**Remarks/Arguments**

Application No. 10/564,715  
Amdt. Dated: July 24, 2007  
Reply to Office Action Dated: June 20, 2007

FIG. A – showing the first radiation detector 30 spans more than 90 degrees

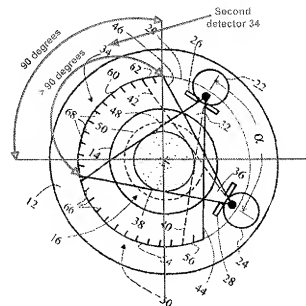
The Office has objected to the drawings under 37 CFR 1.83(a) for not showing every feature of the invention specified in the claims. In particular, the Office asserts that the limitations of claims 6 and 8 are not shown in the drawings. More particularly, the Office asserts that first and second radiation detectors spanning greater than 90 degrees around a gantry, as recited in claims 6 and 8, are not shown in the drawings. This objection should be withdrawn because FIG. 2 of the instant application shows first and second radiation detectors 30 and 34 spanning greater than 90 degrees around a gantry.

This is illustrated FIGS. A and B below, which include FIG. 2 and a coordinate system divided into four 90-degree quadrants. In FIG. A, FIG. 2 has been rotated with respect to the coordinate system to show that the first radiation detector 30 spans an angular interval of the gantry that is greater than 90 degrees. (See also page 5, lines 23-29, of the application). In FIG. B, FIG. 2 has been rotated with respect to the coordinate system to show that the second radiation detector 34 spans an angular interval of the gantry that is greater than 90 degrees. (See also page 5, line 20 to page 6 line 2, of the application).

Hence, the drawings show the features recited in claims 6 and 8, and this objection should be withdrawn.

FIG. 2

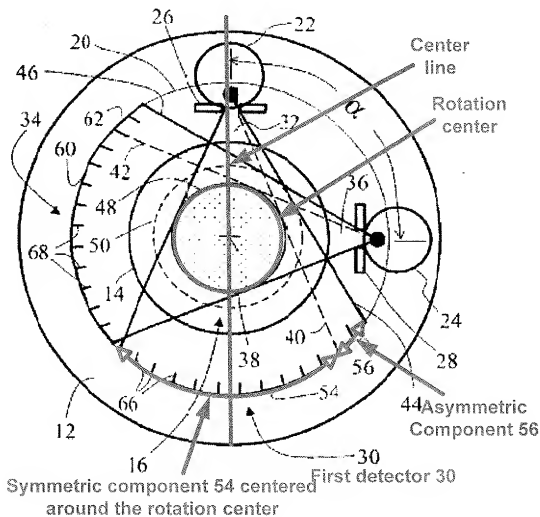
With respect to **claim 5**, the Office asserts that the claim limitation that the angular spacing of the detector to the source defines both symmetric and asymmetric beam components with the symmetric component centered on the rotation center is vague and indefinite insofar as it is unclear how it is possible to have both symmetric and asymmetric beam components. Applicant's representative traverses this rejection.

FIG. 2 of the instant application is reproduced below with annotations showing the symmetric component 54 centered around the rotation center and incident on the first detector 30, and the asymmetric component 56 incident on the detector 30. As recited in claim 5, the high resolution portion of the first radiation detector 30 is arranged to receive the symmetric beam component 54, and the low resolution portion of the first radiation detector 30 is arranged to receive the asymmetric beam component 56. FIG. 2 clearly shows the claimed aspects, which are not vague and indefinite at least because they clearly indicate that the angular spacing of the detector to the source defines both

symmetric and asymmetric beam components. (See also page 7, line 33 to page 8, line 8, of the application). In view the above, this rejection should be withdrawn.
